From: Pederson Ronda M (AREVA NP INC) [Ronda.Pederson@areva.com]
Sent: Thursday, July 16, 2009 2:52 PM
To: Tesfaye, Getachew
Cc: BENNETT Kathy A (OFR) (AREVA NP INC); DELANO Karen V (AREVA NP INC); BEELMAN Ronald J (AREVA NP INC)
Subject: Response to U.S. EPR Design Certification Application RAI No. 212, FSAR Ch. 6, Supplement 1
Attachments: RAI 212 Supplement 1 Response US EPR DC.pdf

Request for Additional Information No. 212, Supplement 1

U. S. EPR Standard Design Certification

Application FSAR Ch 6

Figure 2.3.3-1—Severe Accident Heat Removal System Functional Arrangement

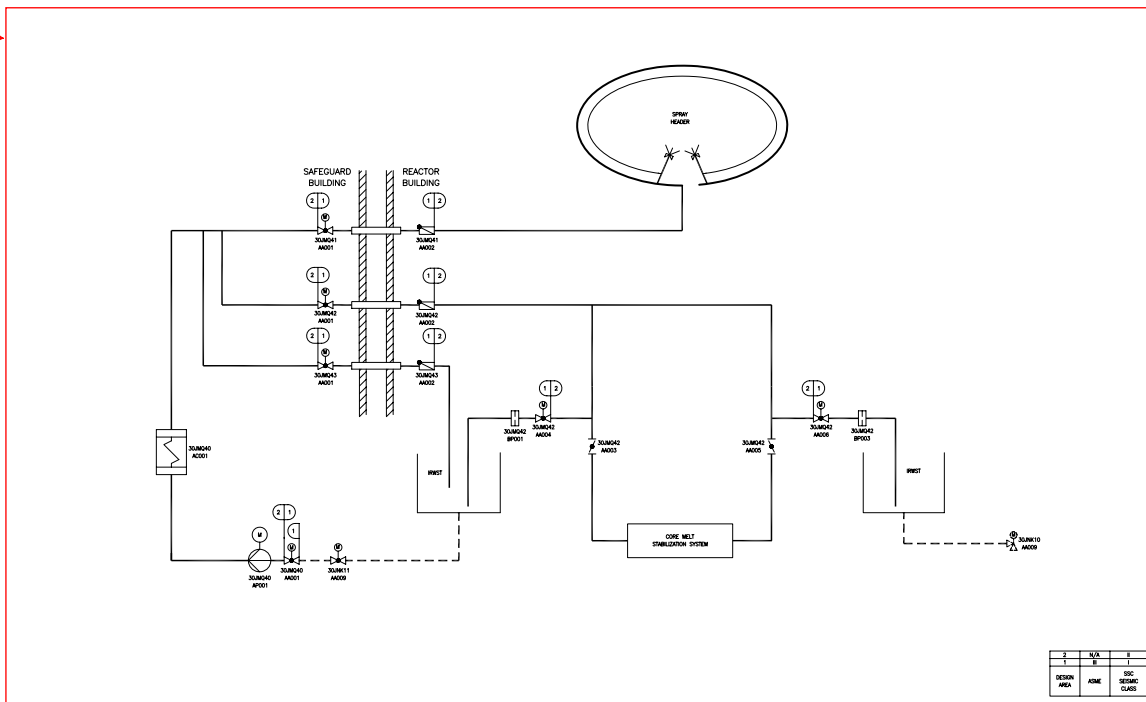
Therefore, describe the design of the passive flooding lines (two) that connect the IRWST to the Core Spreading Area and how the IRWST core cooling function is accomplished assuming a single failure – active and/or passive - of the components in the passive flooding line. Discuss the basis for assuming component failure (spurious opening) associated with the normally closed 'passive flooding valve' and when this is postulated to occur. Discuss if inadvertent (spurious) opening of a "passive flooding valve(s)" is consequential to the IRWST safety function and describe the analysis inputs and assumptions that support the conclusion. Discuss what, if any, automatic or manual actions are necessary to ensure the IRWST can perform its core cooling safety function assuming an inadvertent (spurious) opening of a "passive flooding valve(s)"

In accordance with RG 1.206 C.I.6.3.2.1, provide a simplified drawing depicting all components in the flow path from the IRWST to the spreading area using the passive flooding line. This simplified drawing should be depicted in the FSAR. [Follow-up question for RAI 111, Question No. 06.02.02-8.K.15; related to RAI 212, Question 06.02.02-23 above]

The design of the passive flooding lines has been revised. The following design changes will be incorporated into the U.S. EPR FSAR in accordance with the attached mark-up.

1. One of the motorized isolation valves in each of the passive flooding lines was removed.
2. The normal operating position of the remaining motorized isolation valves was changed from "normal open" to "normal closed" position.
3. The motorized isolation in each remaining passive flooding line is powered from separate divisions (Division 1 and Division 4) and backed by 12-hour uninterruptible

The design of the passive flooding lines has been revised (see Response to Question 06.02.02-23). U.S. EPR FSAR, Tier 1, Figure 2.3.3-1 — Severe Accident Heat Removal System Functional Arrangement, and U.S. EPR FSAR, Tier 2, Figure 19.2.2 — Severe Accident Heat Removal System, will be changed according to the attached markup to reflect the design change.

U.S. EPR FSAR, Tier 1, Figure 2.3.3-1 will be revised as described in the response and indicated on the enclosed markup.
